Re: **Glebe Heights**  
**Lot 236**  
T.M. 56 B. 20 P. 134

SHEET 1 OF 1  
SITE PLAN

### GLEBE HEIGHTS

### CONFIRMATION OF PRE-FILE (2025-0048-P)

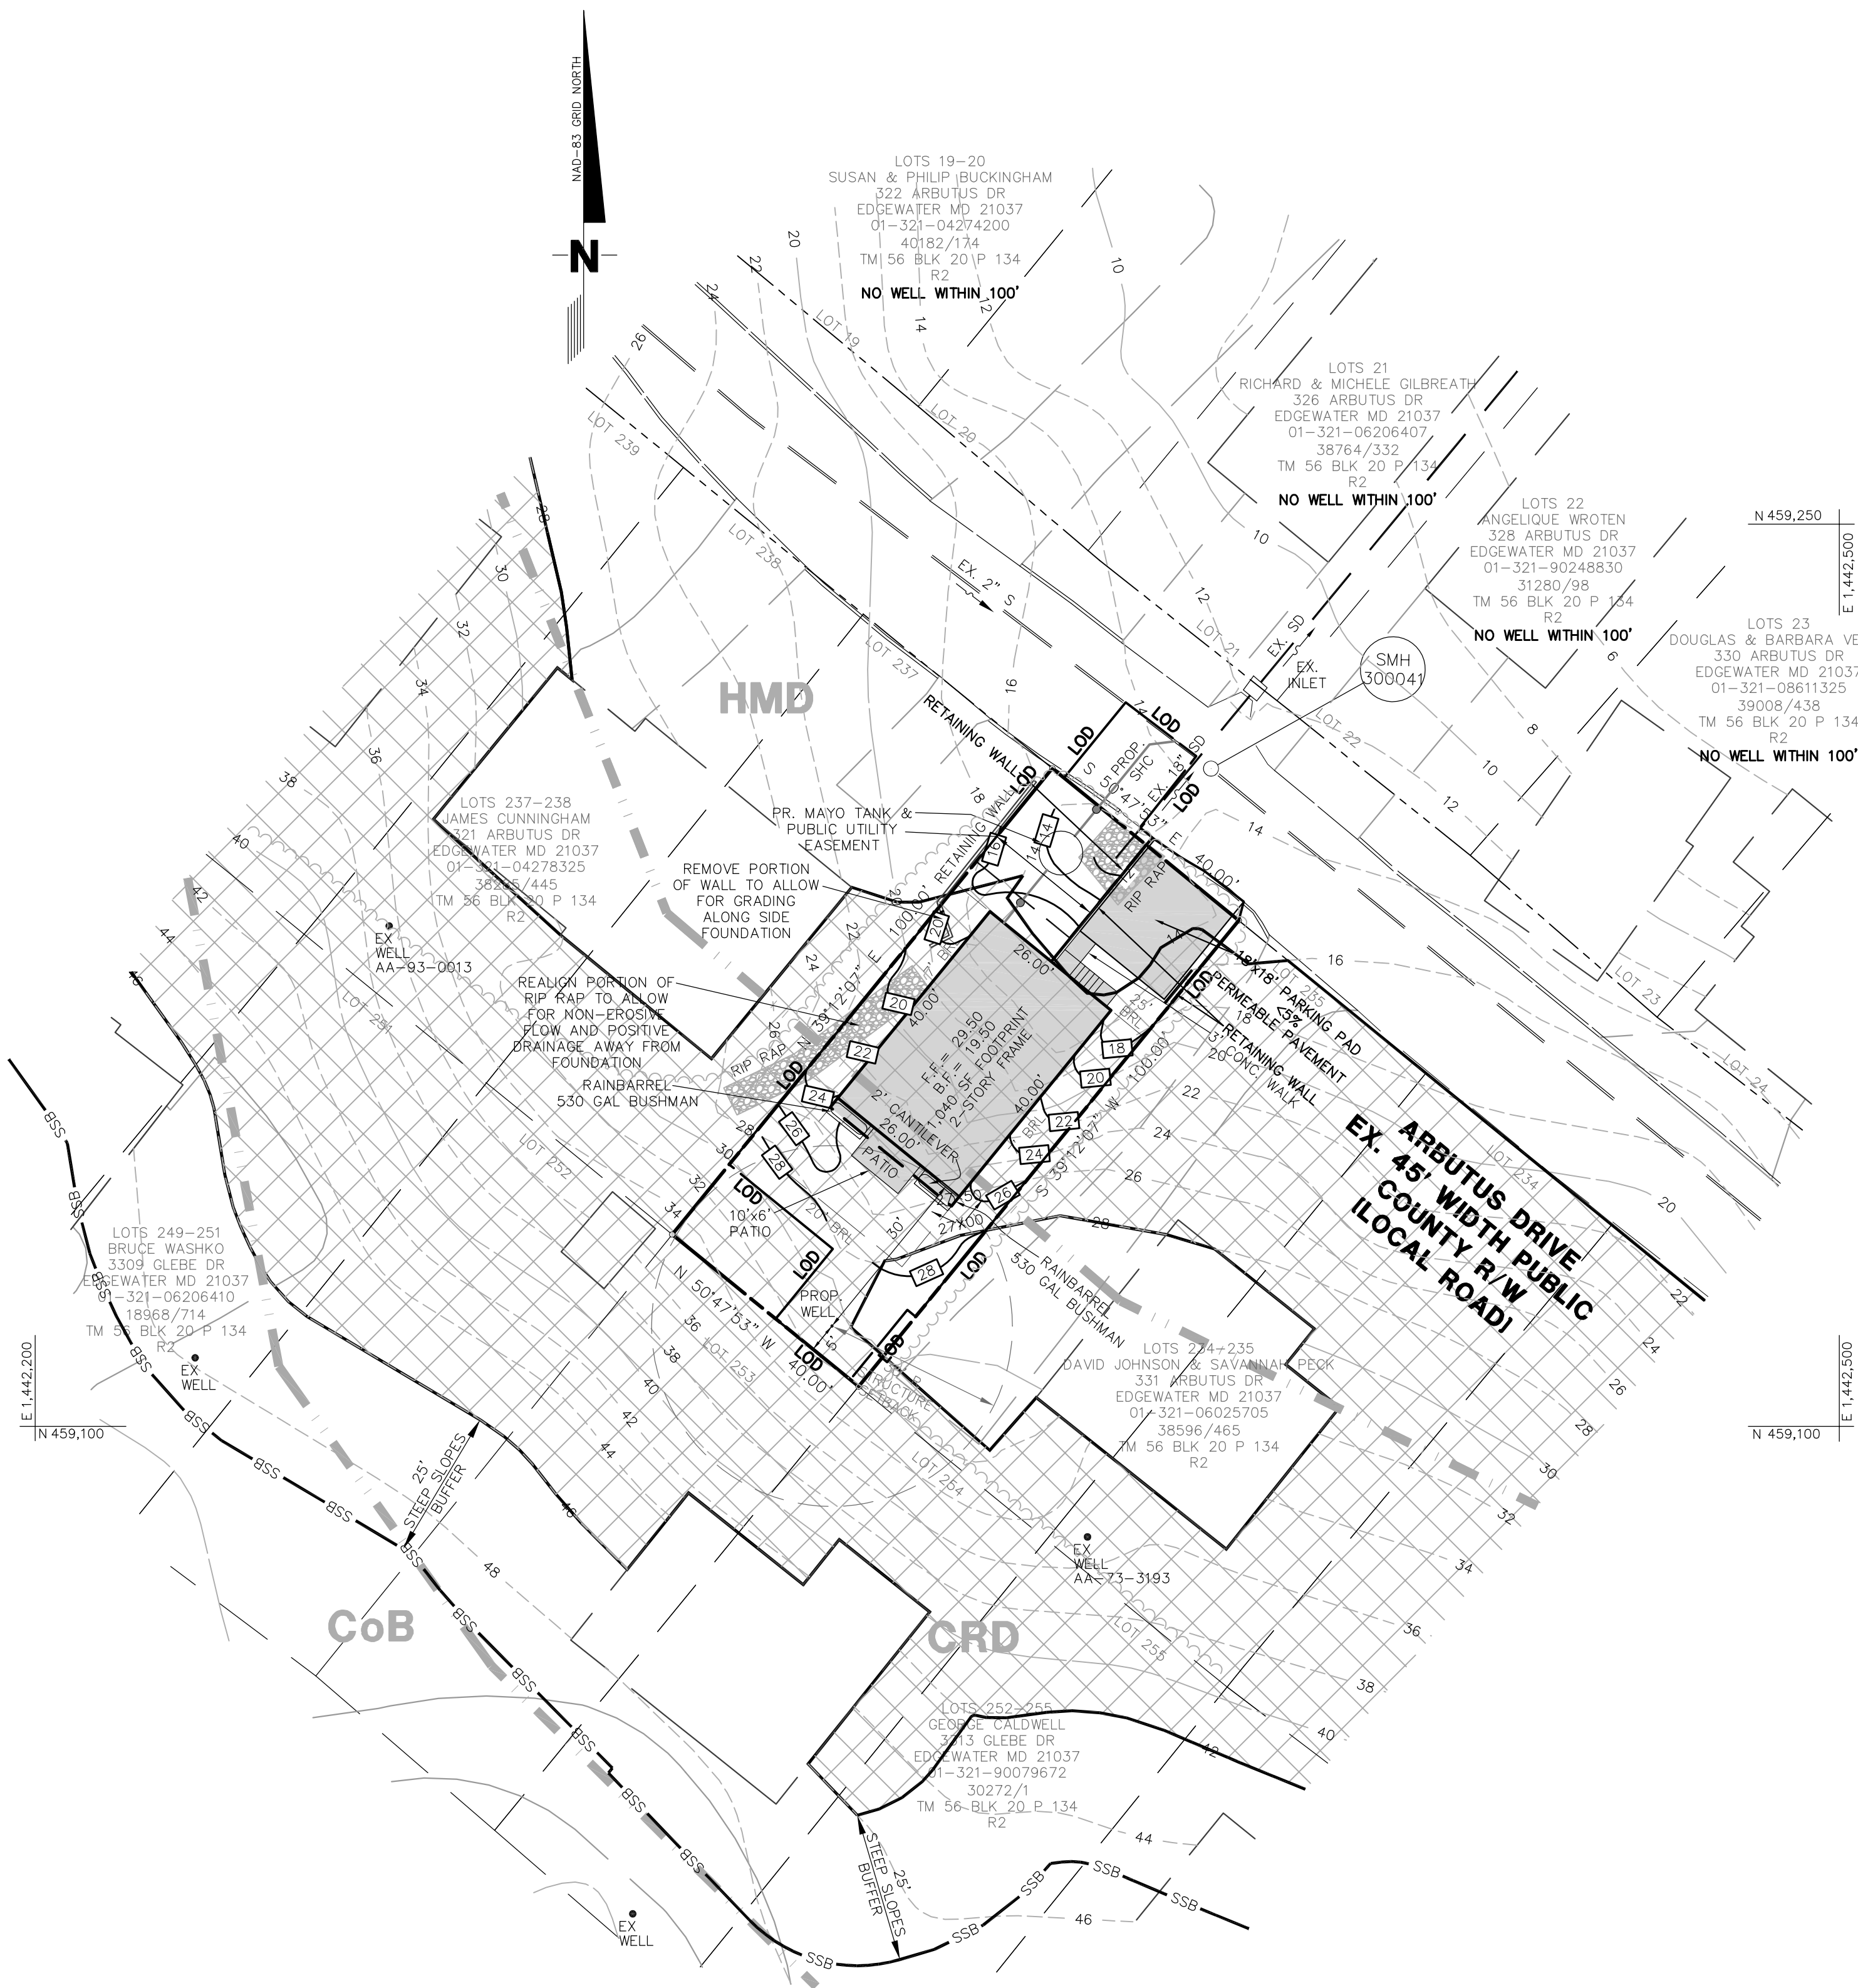
The request for additional coverage cannot be supported. Article 17-8-402 already provides additional coverage that exceeds the 15% coverage limitation for grandfathered lots based on lot size. This Office would not support a variance to this provision for a new home on a vacant lot.

We offer no objection to the request to disturb steep slopes provided the applicant can demonstrate that the disturbance has been minimized.

It should be noted that this lot serves as a conveyance area for stormwater runoff to a pipe at the edge of the road which then conveys the water under the road out to the shoreline. Development of this lot should be reviewed by I&P so that it does not interfere with this conveyance process.

1. Revise the spelling in Item #2 of the Nature of Variance note.
2. We defer to the Department of Health for a reduced setback of a proposed water well from a property line.

3. Revise the Site Analysis note to denote the Private Well and Public Sewer both as "Proposed".
4. Revise the Legend to be appropriate for the conditions present on the plan, force main sewer rather than gravity, water lines are not present, etc.

5. Proposed and existing tree lines are missing from the plans.
6. Add an LOD line to the plans.
7. Label the material and widths of the stairs and sidewalks on the face of the house. Also note the dimensions and material of the patio behind the house.

8. Is there a retaining wall on both the left and right side of the driveway because the proposed 14 contour appears to end abruptly? If so, label both of them or regrade the 14 contour.

9. It appears the proposed 530-gallon rain barrels are both set in the swales on each side of the house. Show the required foundation/surface the barrels must be placed on per the manufacturer's details, as the foundations/surfaces will restrict the flows and change the grading within the swales.

10. Per Geocortex it appears a lateral for the pressure sewer may already be existing. This must be located prior to the formal Variance application being made, as it will affect the proposed locations of the Public Utility

Easement and associated proposed Mayo Tank, driveway, and house. There may be a conflict with the existing public storm drain inlet.

11. The existing public inlet in the front yard appears to be removed or turned off. What is to become of it? Note, no other utilities will be allowed in the sewer utility easement without the Department of Public Works' written authorization per II.E.1.a.6) on page VII-9 of 40 of the DPW Design Manual, Chapter VII Sanitary Sewers. A modification may be required as part of the written authorization.

12. A portion of the neighbor's retaining wall is on this property. Show and label the existing easement. If there is no easement, what is to be done?
13. Can a portion of this retaining wall be removed to grade the property without damaging the adjacent property? What is the legal situation associated with the neighbor's wall on this property, assuming it is supporting the neighbor's house, driveway, etc. and assuming it has most likely been in-place for years?

14. An existing riprap channel is on the property. Show and label the existing easement. If there is no easement, what is to be done?
15. Note where the topo is from, month, year, and firm. Note if field run, aerial or County. If County, note what year it is from. Note, the most current County topo is from 2023.

16. The development may be detrimental to the Public Health as a house is proposed at the bottom of a riprap channel upstream of the only inlet on this side of the street in this area.

17. The development may impair the appropriate use or development of the surrounding properties and the development of this lot if a house is placed at the bottom of a riprap channel upstream of the only inlet on this side of the street in the area.

18. Provide a qualified professional review of the condition of suitability of steep slopes; ensure the proposed improvement including quality and other limits do not adversely impact the intensity of the slope and can cause slope failure.

19. Provide soil boring(s) and show any seasonally high-water table elevation(s) since a basement is proposed. If the water table is encountered and is higher than the proposed basement floor elevation, it might be intercepted by the basement, creating issues for the homeowner, public safety and other safety impacts. A Qualified Professional will also be required to perform a feasibility of the basement and present potential mitigation options to address the issue.

20. Feasibility of the development must be determined considering the terrain, environmental factors, physical characteristics of the prevalent soil strata and its ability to suitably treat the proposed storm water runoff and surface groundwater conditions. The swm practice locations and existing overland flow (riprap channel) should not require any additional regulatory permitting. The proposed development must be compatible with the surrounding community and consider downstream properties in design.

21. Stable conveyance of all stormwater (upstream and on this lot and applied rain barrel effluent) and maintenance of natural flow patterns must be demonstrated.

22. Ensure the proposed improvement including runoff, seepage, and slope saturation does not adversely impact the integrity of the slope and potential impact of slope failure and negatively affect the proposed home.

23. The applicant should evaluate and implement site planning alternatives in accordance with 18- 16-201.
24. Identify the site outfall to review the site plan and provide feedback regarding potential impact.

25. All stormwater conveyance systems shall be designed so that no building or habitable structure, either proposed or existing, is flooded or has water impounded against it during the 100-year storm event.

26. Evaluate and report on the site to ensure any existing or possible proposed downstream flooding and flooding on the proposed development including nuisance flooding issues will be exacerbated by the proposed development.

27. Design professionals should review site runoff and potential (negative, adverse) impacts to neighboring properties, due to changed grades/elevation/flow paths on a proposed project.

28. It is not clear why the additional coverage is necessary.
29. The above is provided as a courtesy review as information for review and consideration comments for this Pre-File. Additional comment will be generated at the Variance stage and at the Permit stages.

The site plan should add dimensions from the proposed improvements to the front, rear, and side property lines. Please identify the heavy outlined area near the property's southernmost corner. This heavy outlined area overlaps the east side property line, and is difficult to decipher its purpose. The letter of explanation provides little to no justification on why excess Critical Area lot coverage is warranted. Please explain why the allowance of excess Critical Area lot coverage is the minimum necessary to afford relief or why the applicant doesn't have reasonable use of a residential lot without the allowance of excess Critical Area lot coverage.
